RE: A&M Project # 1670-15

Proposed Comprehensive Permit
648 & 652 Canton Ave.
Response to Peer Review Comments

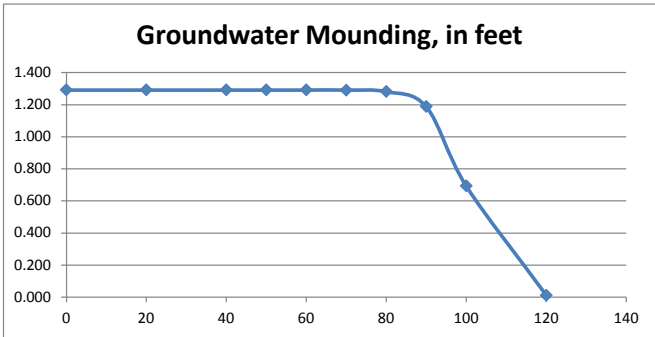
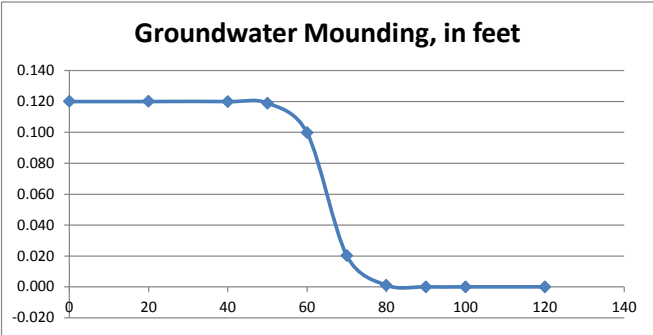
c) In accordance with the previous comment, HW is unable to confirm the soil testing information used in the design of the subsurface infiltration systems. However, both systems

are located within a "fill" area, which will likely provide adequate separation to the seasonal high groundwater table. Based on the narrative description, the infiltration rates used seem appropriate, but will need to be confirmed based on HW's review of the additional soil testing information to be submitted by the Applicant.

c) See Comment b above. Additionally, attached hereto, A&M has provided the Hantush calculations required for the groundwater mounding analysis as required when a system has less than four feet of separation to the estimated seasonal high groundwater elevation.

SITE PLAN

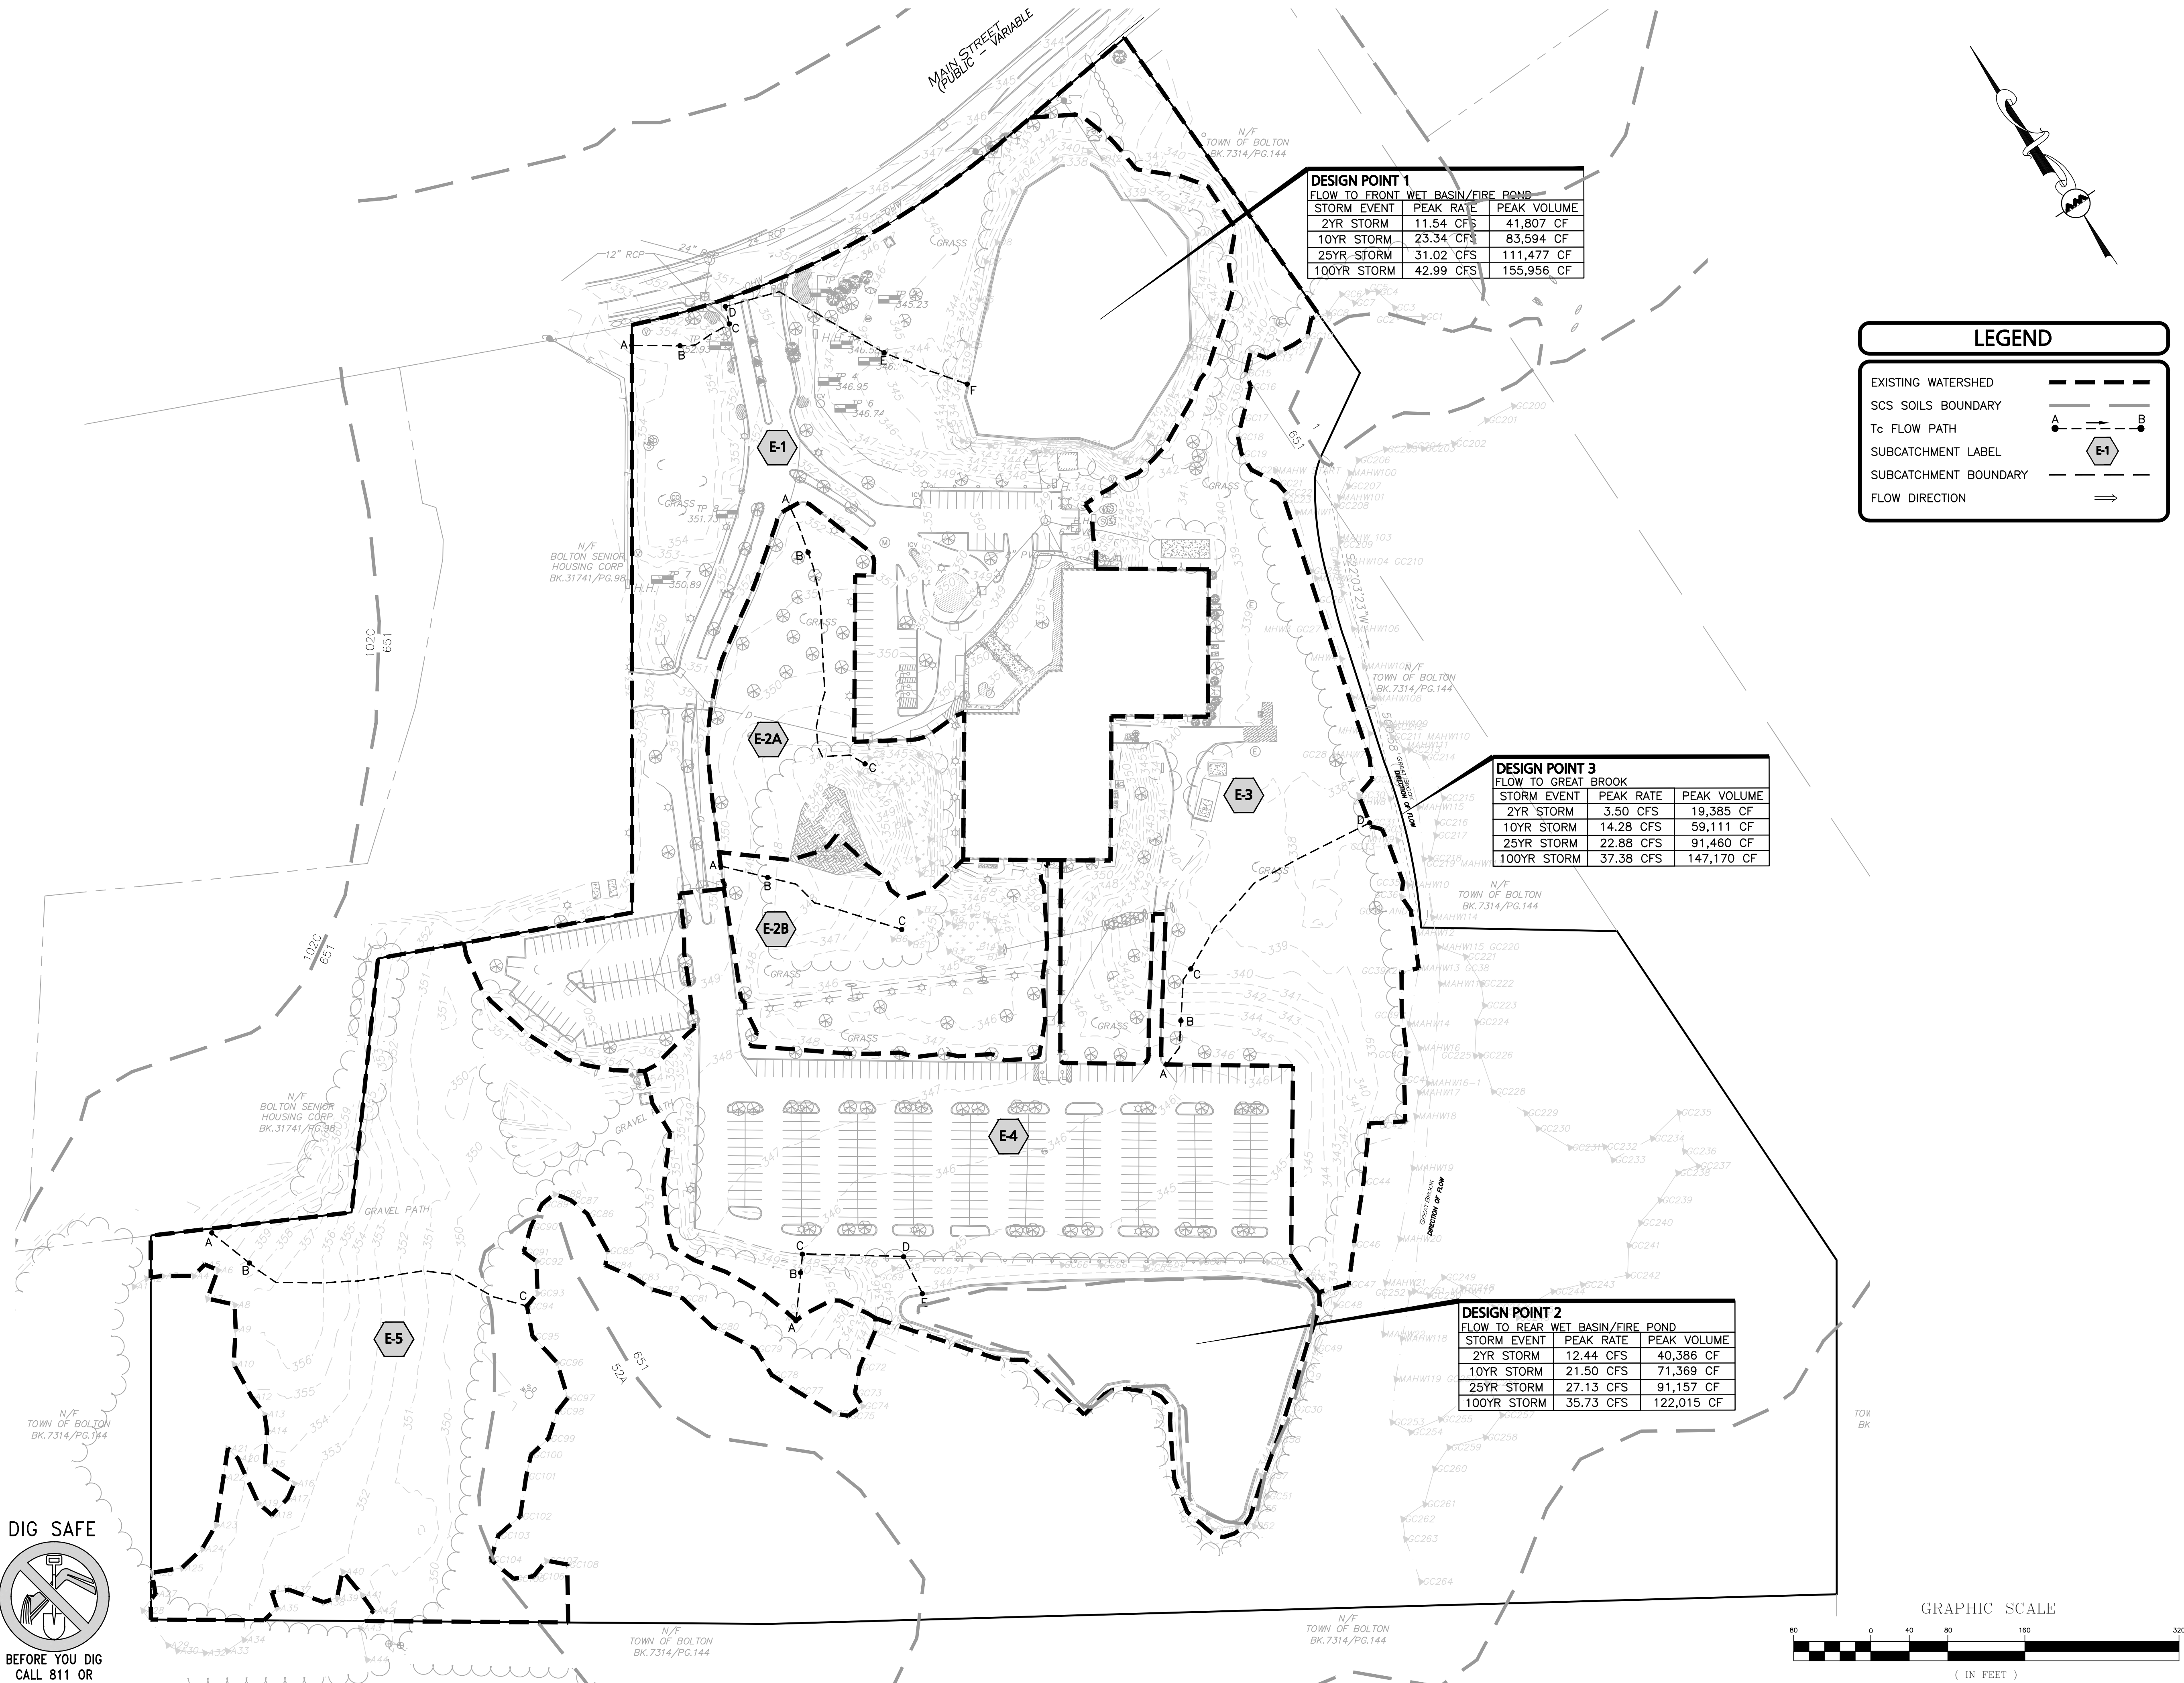
- c) The Applicant included plan sheet O&M 1 entitled "Operation & Maintenance Plan" which depicts the key elements of the stormwater management system for reference during long term maintenance activities. HW recommends that all water quality structure labels are updated to call out the specific Contech products being used, since each has individual O&M requirements. It may also be appropriate to coordinate further with Contech to see if future maintenance could be simplified by reducing the number of different Contech products being used in the design.*

- d) Sheet O&M 1 should be updated to call out the inlet and outlet locations for both of the existing wet basins/fire ponds, so that they can be regularly inspected for signs of erosion or blockage. Even though the rear wet basin is no longer considered part of the project's drainage system, it is still important that it is inspected regularly.*

c) The specific Contech information labels have been added to the Revision 1 site plans as recommended. A&M has not endeavored to coordinate specific models with the manufacturer at this time, but can solicit this information prior to construction to simplify inspection and maintenance.

d) The inlet, outlet, and weirs for the existing fire ponds have been added to the site plans as recommended.

PROPOSED WATERSHED PLAN – PWS-1

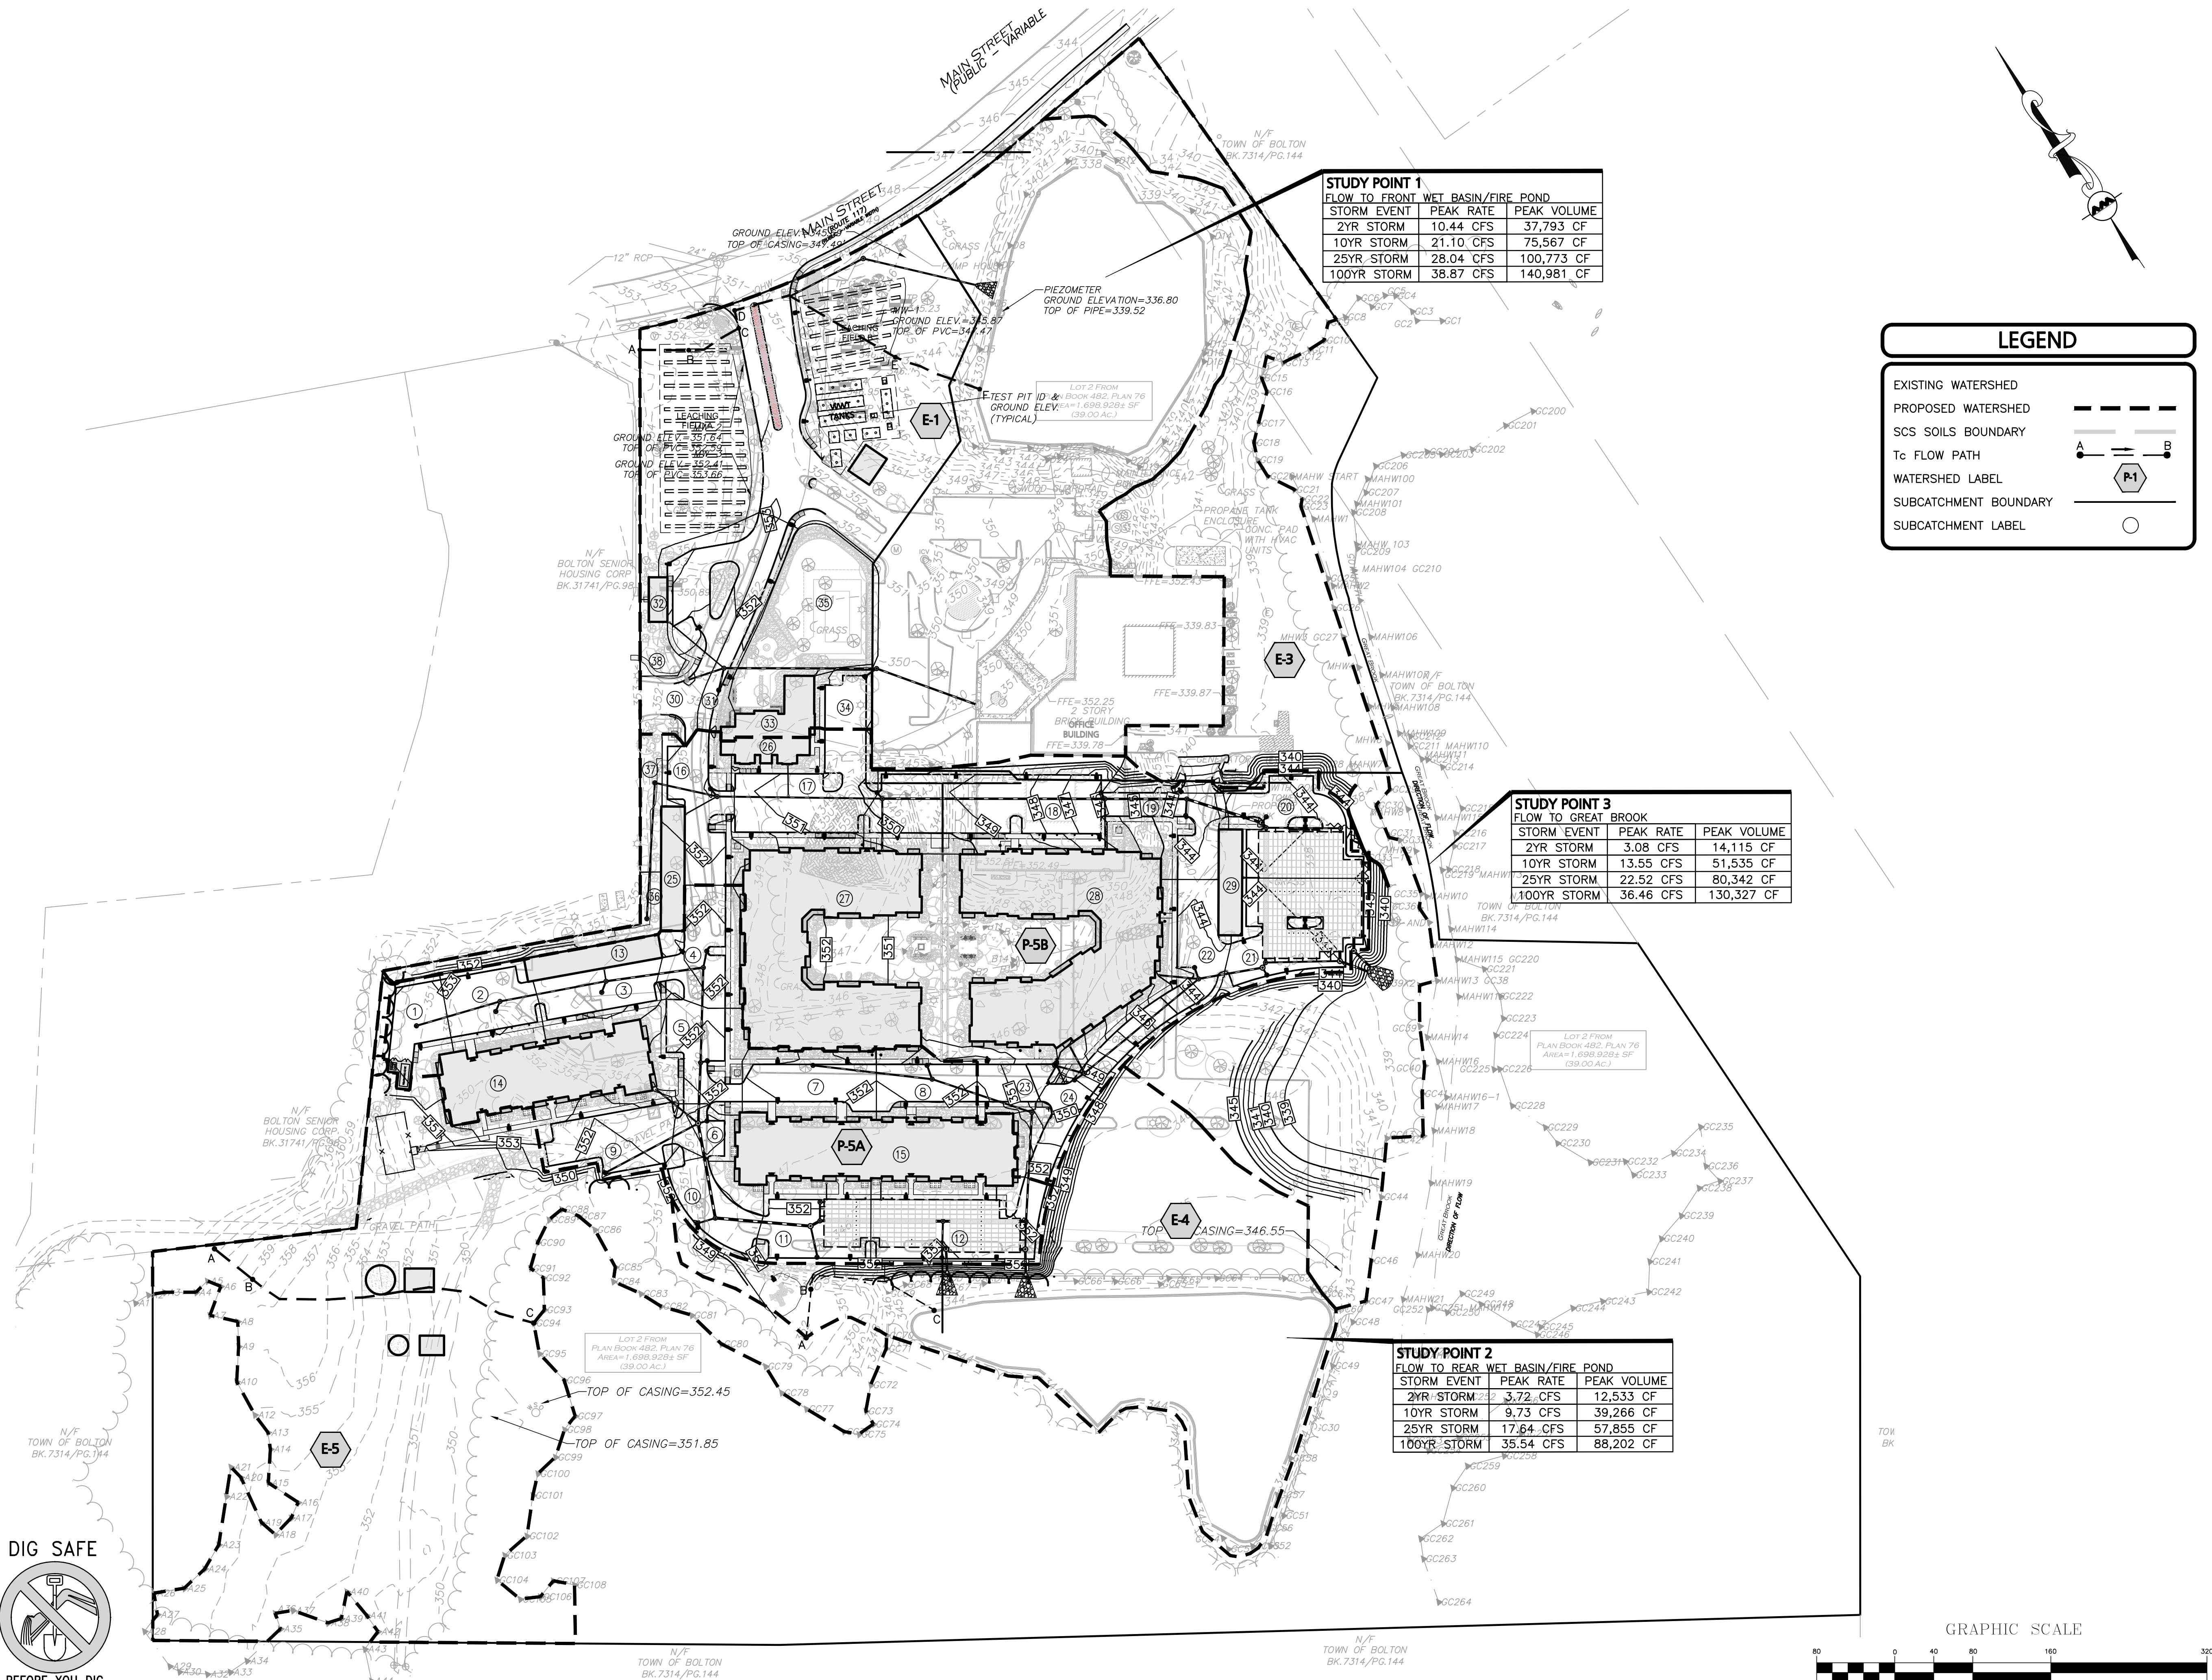
- c) The Applicant has chosen to include two separate areas within Subcatchment E-3, both technically are tributary to Great Brook, however one side flows into a large wetland before reaching Great Brook. HW recommends that the Applicant separate these two areas of Subcatchment E-3 and revise the HydroCAD model accordingly.*

Response 2: a) No further response required. However, as a result of some minor changes and HydroCAD routing, the runoff rates and volumes are slightly different than the original submission. This is largely due to the separation of existing watershed E-3 into two (2) sub basins as requested. The updated figures are shown in the table below:
